DEVELOPMENT REVIEW COMMITTEE

580 BRINY AVENUE APARTMENTS – Site Plan

Request: Major Site Plan
P&Z Number: 22-12000043
Owner: Claridge Homes Beachboys LP
Project Location: 580 Briny Avenue
Folio Number: 494306060260
Land Use Designation: Medium-High (MH 16-25 DU/Acre)
Zoning District: RM-20/AOD (Multiple-Family Residential 20 /Atlantic Overlay District)
Commission District: Andrea McGee (District 1)
Agent: Andrew J. Schein
Project Planner: Diego Guevara (954-786-4310 diego.guevara@copbfl.com)

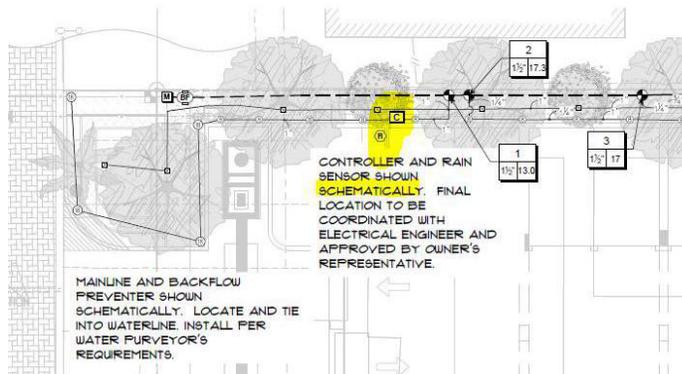
44. Staff requirement: Provide medium canopy trees in parking islands along rear drive aisle.

RESPONSE: Silver Buttonwood(4) provided in parking island.
